Agenda
Lane Cove Local Planning Panel Meeting
10 December 2024

Lane Cove Local Planning Panel 10 December 2024
16 GAMMA ROAD, LANE COVE

Item No: LPP11/24
Subject: 16 Gamma Road, Lane Cove
Record No: DA24/130-01 - 71630/24
Division: Planning and Sustainability Division
Author(s): Sam Wilson

Figure 2: Proposed Front Yard and Basement Garage Section (Source: Applicant)

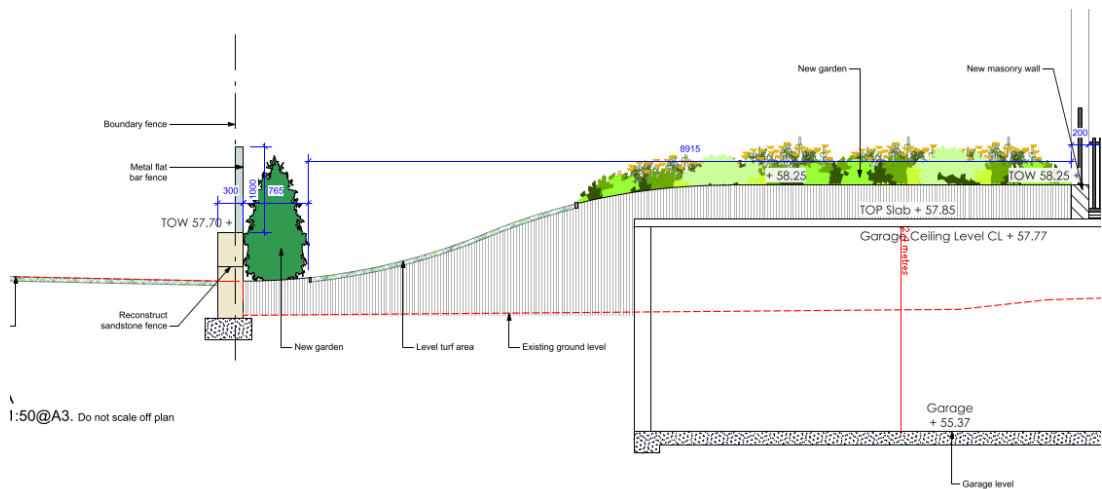
The most notable section of earthworks pertains to the basement garage and front yard. The proposed design features a basement garage that is fully encompassed by earth and vegetation. Given the subterranean position, the proposed garage would present a moderately sloped mound of earth that consists of small vegetation species (shrubs and grasses). The resultant 1m level difference would maintain a moderately sloped grassed area the front of the site – and be topographically synonymous to the existing.

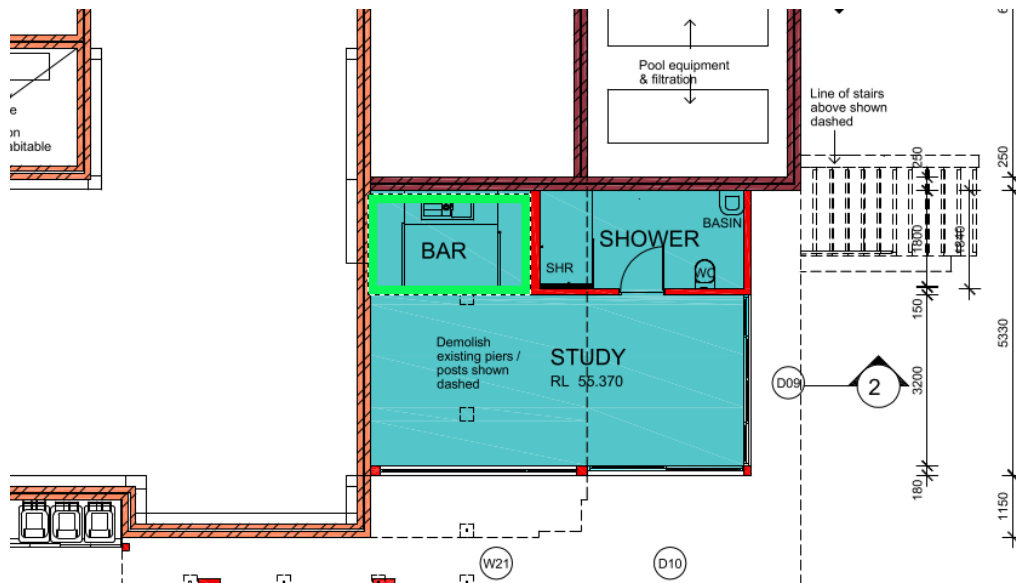
- a) The first-floor balcony depicted on drawing A202, revision C, dated 26/08/2024, is to incorporate a 1.8m privacy screen at the northwestern extent of the balcony. The area is heightened in red in the below diagram;

b) The proposed studio shown on drawing A201, revision C, dated 26/08/2024, is to remove the 'bar' from the architectural plans. The studio is not to include any cooking infrastructure. The area is highlighted in green in the below diagram.
